P.O.A.D.P. PLAN
for
EISENHAUER ROAD 21.8

Re: Eisenhower Road 21.8

POADP # 639

SUBJECT: Eisenhower 21.8 POADP Level II T.I.A.

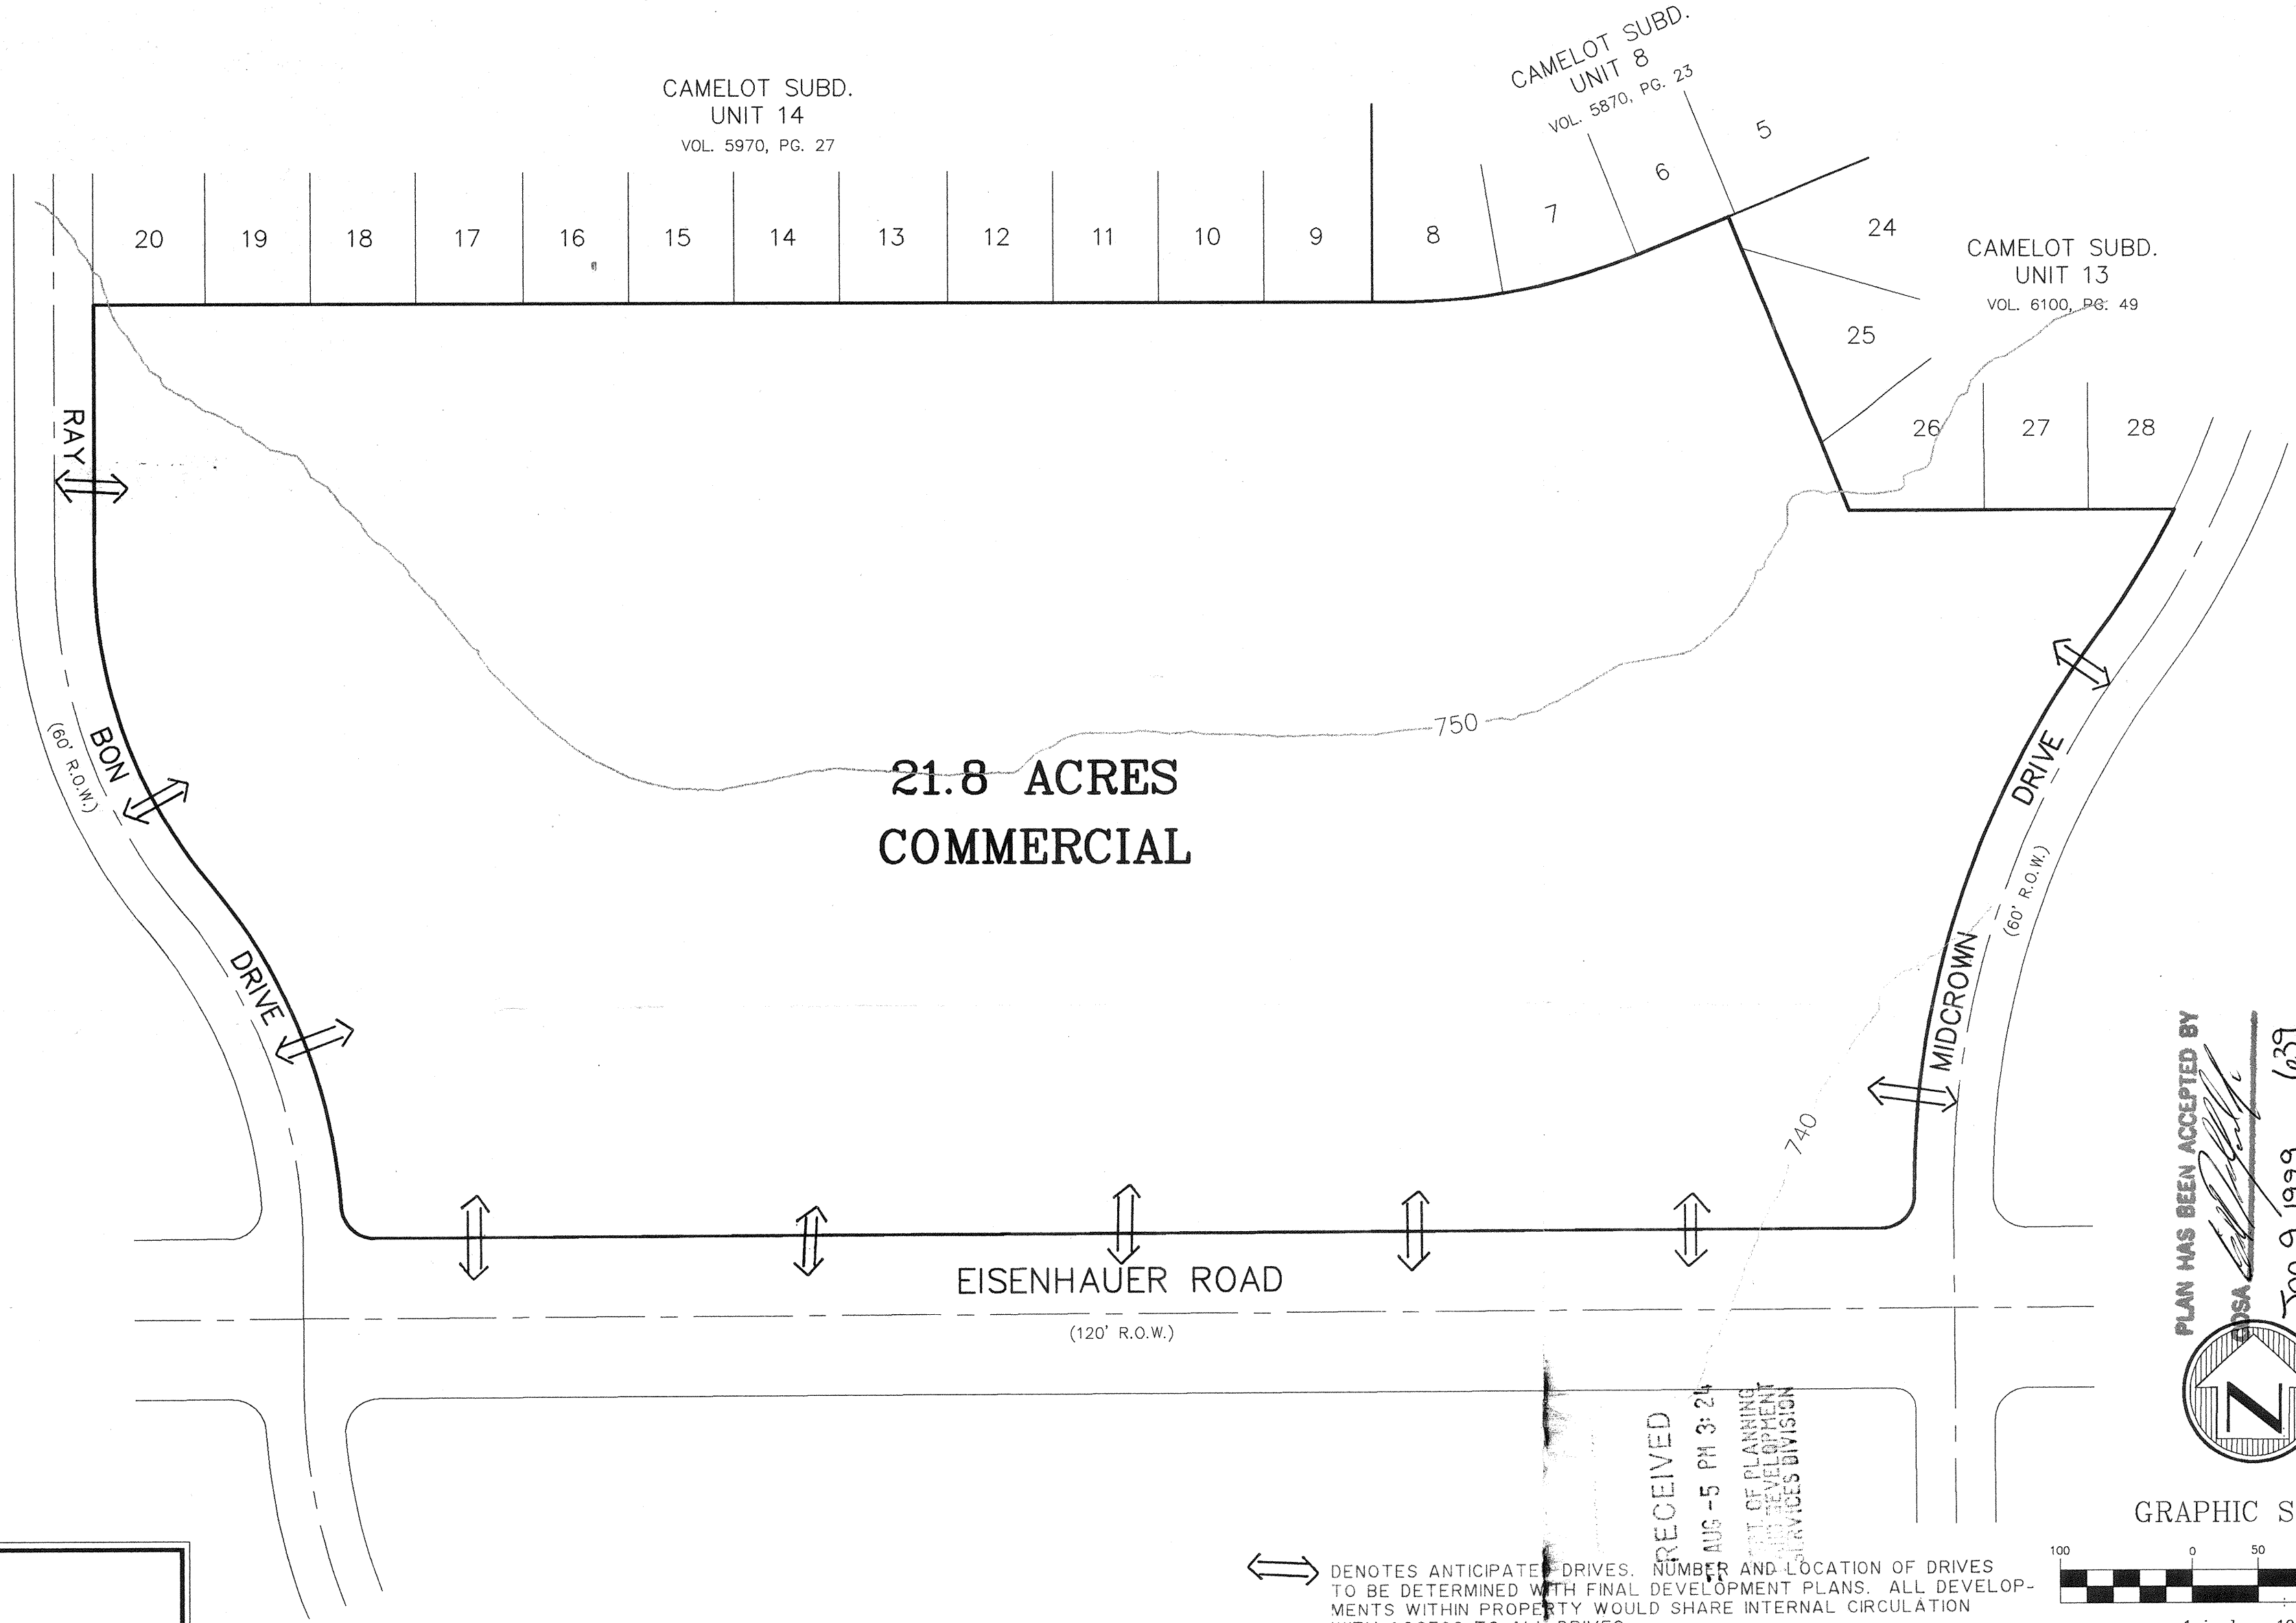
- Based on the topography, a Flood Plain Study and drainage review will probably be required during the platting process.
- In consideration of public safety and convenience, excessive grades by reason of topography should be avoided in street layouts and arrangements.
- Access along Eisenhower Road, Midcrown Drive and Ray Bon Drive will be limited to two driveways each, with the understanding that the development would include shared access and internal circulation.
- This development will need to comply with tree preservation ordinance #85262. For information about these requirements you can contact Building Inspections at 207-7102.
- It will be expected that you will plat all of the property depicted in your POADP, to include: floodpains, drainage areas and open space.
- I would encourage you to work closely with the school district, so that they can plan accordingly.

Comments: Drainage easements will be require
and will be. ~~over~~ address during the
platting process.

Proposed to consist of various commercial lots, this property will is estimated to generate up to 991 peak hour trips for a shopping center based on the 6th edition of the ITE Trip Generation Manual. With the intent of shared driveways and common access, these trips will be distributed through two access points on Eisenhower Road, two located on Midcrown Drive, and two located on Ray Bon Drive.

Fewer driveways may be required on Midcrown and on Ray Bon.
